ALESIS

MMT-8 (MT)

Service Manual

ECN HISTORY

EXISTING REV: H

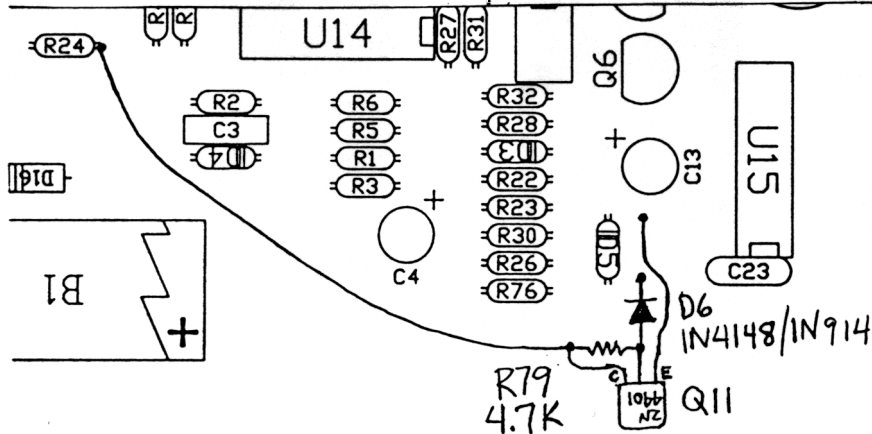
DESCRIPTION OF CHANGE: ADDITION OF THE FOLLOWING PARTS TO UNITS ~~USING~~
~~1257 SPAMS ONLY:~~

- (1) - 4401 TRANSISTOR - Q11
- (1) - 4.7KΩ RESISTOR R79
- (1) - JUMPER (SEE BELOW)

REASON FOR CHANGE: CRASHING MEMORY DUE TO VOLTAGE DIFFERENCE BETWEEN DATA LINES & SRAM VCC.

P/N: 9-40-1013

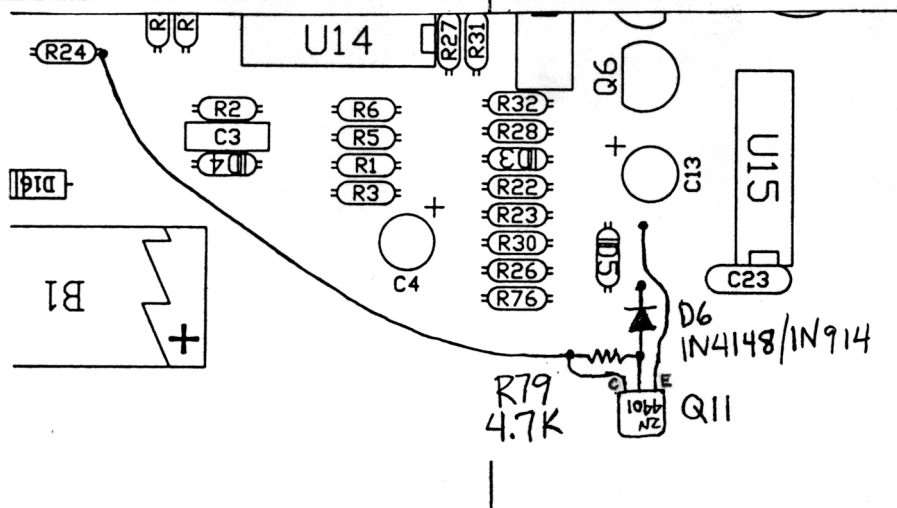
DESCRIPTION OF CHANGE: ADDITION OF THE FOLLOWING PARTS TO UNITS USING '257 SRAMS ONLY:

- (1) - 4401 TRANSISTOR - Q11
- (1) - 4.7K RESISTOR - R79
- (1) - JUMPER (SEE BELOW)

REASON FOR CHANGE: CRASHING MEMORY DUE TO VOLTAGE DIFFERENCE BETWEEN DATA LINES & SRAM VCC.
